PLANNED UNIT DEVELOPMENT

STAFF REPORT Date: July 16, 2020

DEVELOPMENT NAME 916 Church Street

CONTEMPLATED USE Planned Unit Development approval to allow multiple

SITE PLAN

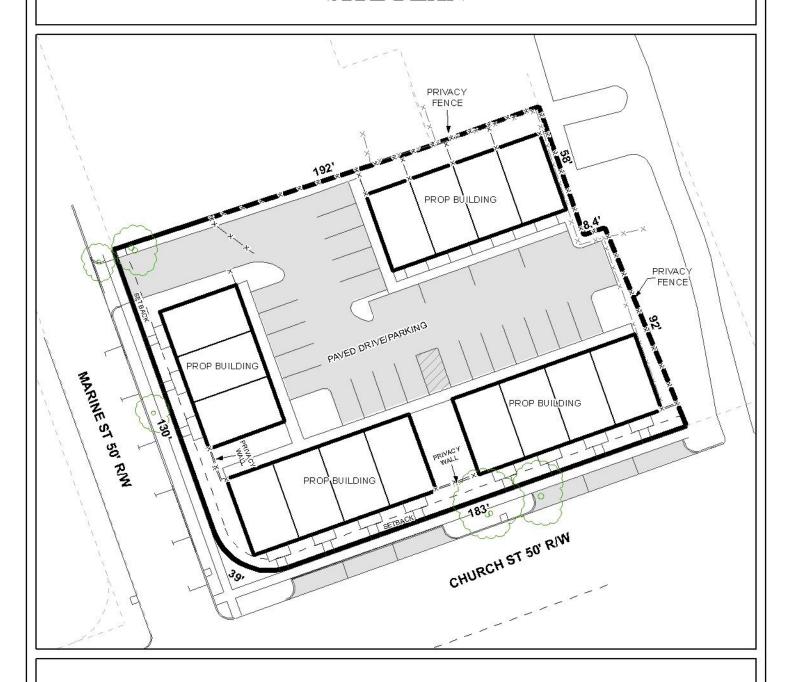
- 1. Add a TITLE to this sheet "PUD SITE PLAN".
- 2. Show and label the existing irrigation well.
- 3. Label the existing and proposed items or provide a legend.

- 4. Revise NOTE #1. Add "PERMITTING" so that the note reads "Any work performed in the existing ROW (right-of-way) such as driveways, sidewalks, utility connections, grading, drainage, irrigation, or landscaping will require a ROW permit from the City of Mobile Engineering Permitting Department (208-6070) and must comply with the City of Mobile Right-of-Way Construction and Administration Ordinance (Mobile City Code, Chapter 57, Article VIII).

- 5. ADD THE FOLLOWING NOTE TO THE PUD SITE PLAN:
 - a. Any existing or proposed detention facility shall be maintained as it was constructed and approved. The Land Disturbance Permit application for any proposed construction includes a requirement of a Maintenance and Inspection Plan (signed and notarized by the Owner) for the detention facility. This Plan shall run with the land and be recorded in the County Probate Office prior to the Engineering Department issuing their approval for a Final Certificate of Occupancy.

- 6. Retain NOTES #2 #5, as shown on the unlabeled application drawing dated 06-15-2020.

The subject site is approximately 30,733 square feet, which allows a maximum density of 18 dwelling units; 15 units are proposed by the applicant. It should be noted that Section 64-5.C.2.c. of the Zoning Ordinance requires 700 square feet of open space per dwelling unit (10,500 square feet). The site plan provides landscape area calculations (6,873 square feet total), and as parking areas are not allowed to be counted as open space, it is apparent that there is a deficit.

Multi-family developments are required to provide 1.5 parking spaces per dwelling unit, or 23 parking spaces. The proposed site plan illustrates 25 parking spaces to be provided on-site with an additional 11 on-street parking spaces proposed adjacent to the development. It should noted that approval of this application would be subject to compliance with Traffic Engineering Comments. Further, Traffic Engineering notes that any parking in the right of way is for use of the public at large, and cannot be restricted to the use of the adjoining property. It should be noted that a compliant photometric plan will be required at the time of permitting.

The Zoning Ordinance requires minimum driveway and drive aisle widths of 24' for two-way traffic. The applicant is proposing a 20' wide driveway, and 20' drive aisles throughout the site, thus providing insufficient maneuvering area. Furthermore, there is a "power gate" illustrated across the driveway onto the site approximately 40'± from the property line. Typically, a minimum of 60' is required, however allowances are made for electronic gates as proposed.

As proposed, the structures are approximately 5' from the front property lines along both Church and Marine Streets, which is allowed by-right in an R-B district. It should be noted that the buildings on the Eastern portion of the property are depicted anywhere from 3.6 to 10-feet from the property line. As the adjacent property is zoned and utilized residentially, a 10' setback would typically be required, however, the site is located in the Oakleigh Garden Historic District, thus based on the Historic District Overlay the setbacks for the site may be in keeping with the setbacks of existing structures within 150' of either side of the property (East or West), on the same side (North) of Church Street. If approved, the site plan should be revised to indicate such existing structures to justify the reduced setbacks. It should be noted that while the Historic District Overlay offers the flexibility of the reduced setbacks, the construction of the structures themselves will be subject to full compliance with Building Code requirements.

As the site is adjacent to residentially utilized properties, a compliant residential buffer must be provided. The site plan submitted illustrates a privacy fence along both the North and East property lines, as well as a "privacy wall" along the building façade, which will block the view of the on-site parking area from the street. If approved, the site plan should be revised to include the height of both the fence and the wall.

Regarding tree planting and landscape area requirements, the site will be in compliance with the minimum amount of landscape area. The applicant should coordinate with staff in regards to tree plantings to insure that any trees placed on site are placed in such a way as to allow them to thrive. A note is on the proposed site plan stating "tree and landscaping compliance to be maintained at existing levels". If approved, this note should be removed.

As previously stated, the site plan does not show compliance with open space requirements or vehicular drive aisle widths. Further, as illustrated in the Traffic Engineering Comments, there appears to be no accommodation for storage of trash cans. Finally, the site had a Subdivision approved previously, but the approval expired. As such, the site is not a legal lot of record, and will be required to go through the Subdivision process prior to development.

- 1) Submission of a Subdivision Application and
- 2) Provision of a revised site plan and/or narrative to address the deficit open space requirements, inadequate drive aisle widths, and illustrate the storage of trash cans and their proposed location for sanitation pick up.
